APPENDIX 11C — PUBLIC COMMENTS 2024

Public Comment Log and Bates-Stamped Page Index

Figure 1: Overview

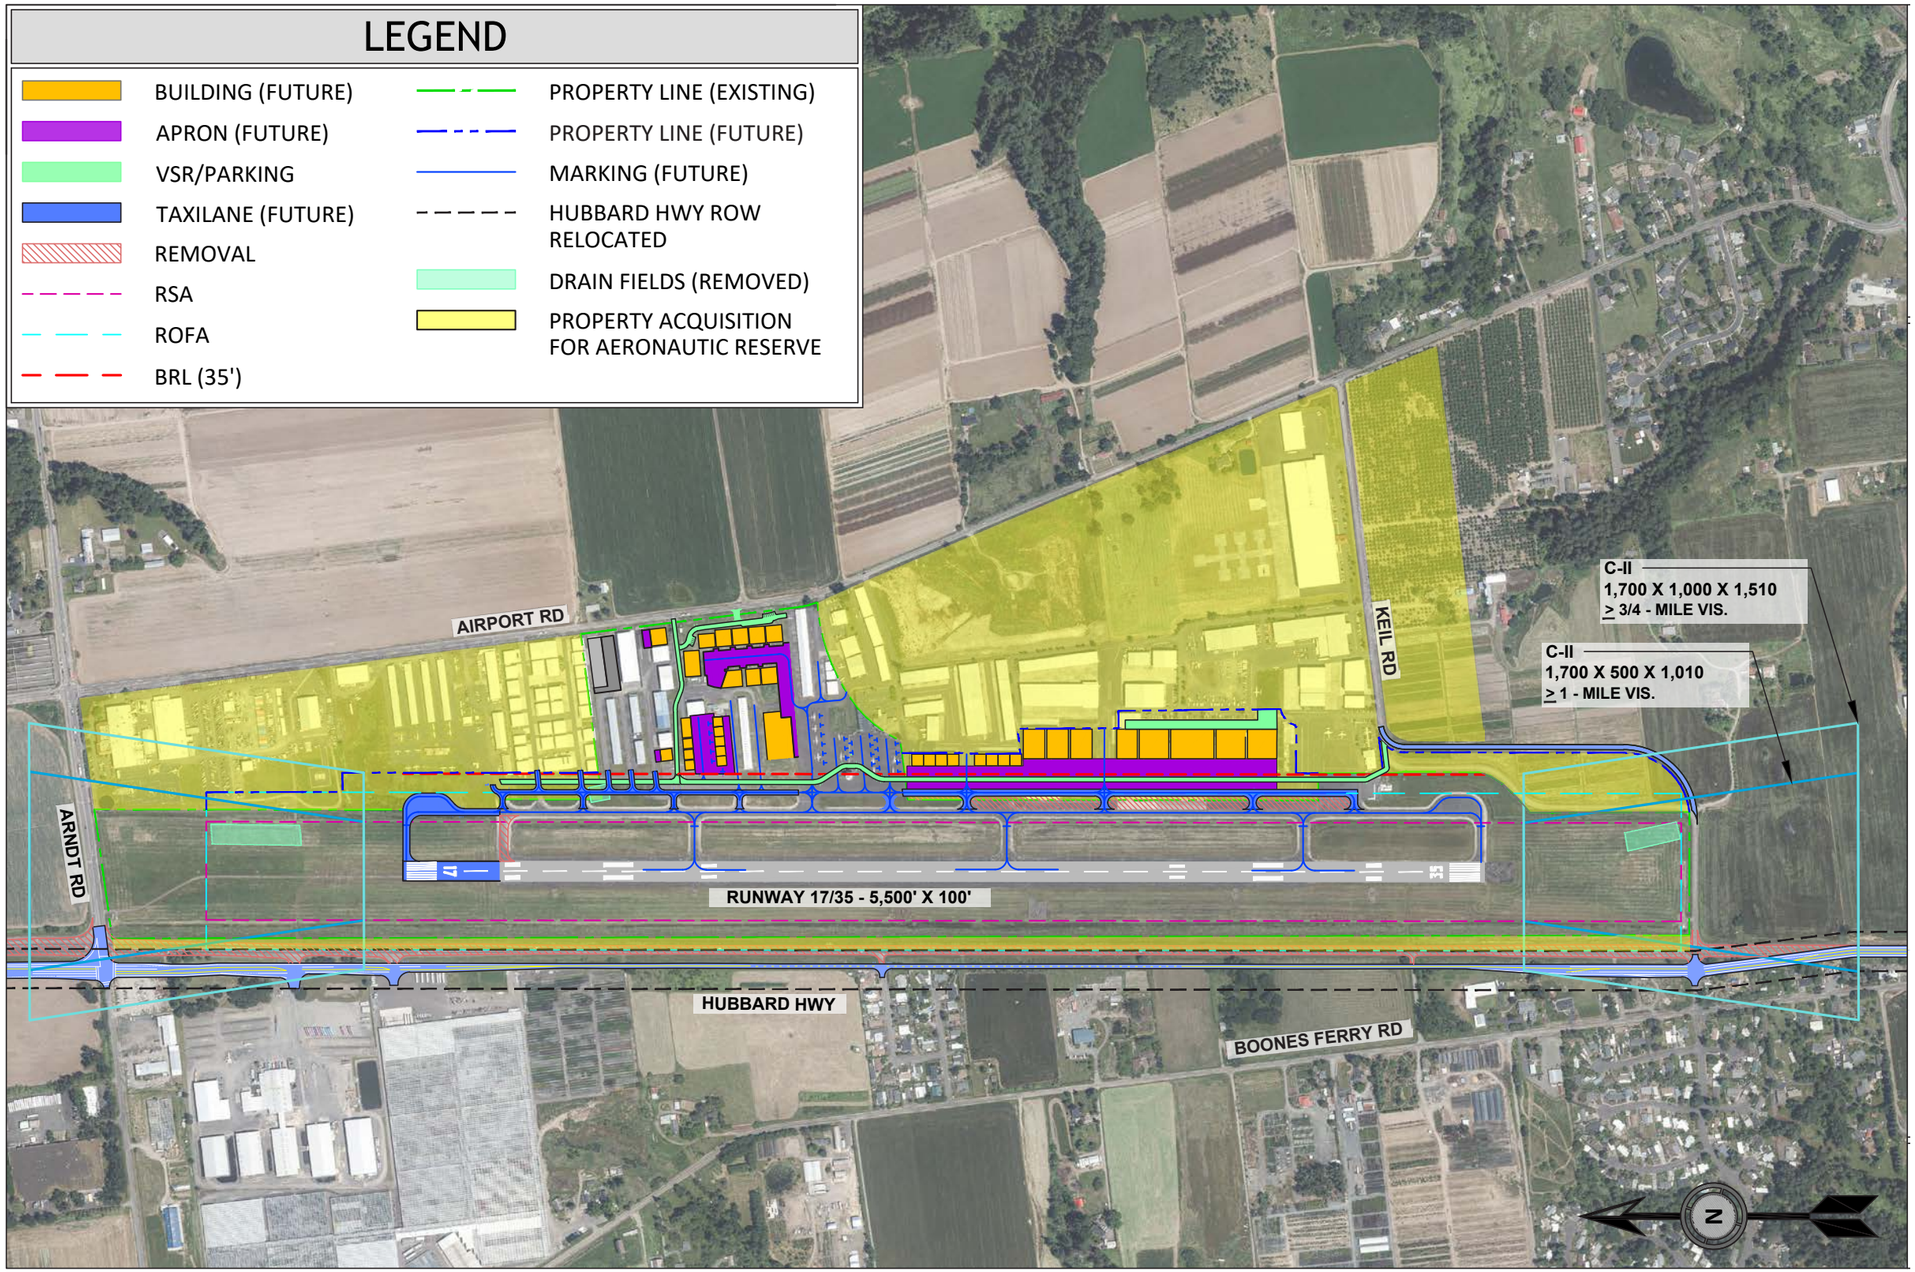
What ODAV did was to decide that a modified Alternative 1A be identified as the preferred alternative (Exhibit 1). This alternative was the best of the three truly terrible alternatives ODAV floated. This one moves Hwy 551 west – but well more than the 32 feet that is needed, puts the internal circulation road along side the active taxiway and runway, removes the septic drain fields to nowhere, fails to expand the airport boundary and still shows ODAV buying up, tearing down front privately owned front row hangars, only to rebuild new hangars that would be leased out by the State. Additionally, the ODAV shows intent to purchase privately owned properties now devoted to aeronautical uses. Newly part of this alternative as of October 16, 2024, is that the critically needed runway extension is planned to languish and is only "phased in" when Hwy 551 is moved. ODAV can do better. And in its history, it has done better.

- Phase in the runway extension at least 500 feet to the north **as an immediate action** regardless of the 32' of imperfect ROFA compliance and, to prove up on safety doing so, submit the Exhibit 3 Modification to Standards to FAA to support it. The FAA will approve it. Call this step an interim measure, subject to moving Highway 551 in the longer term, when funds are available (next bullet).
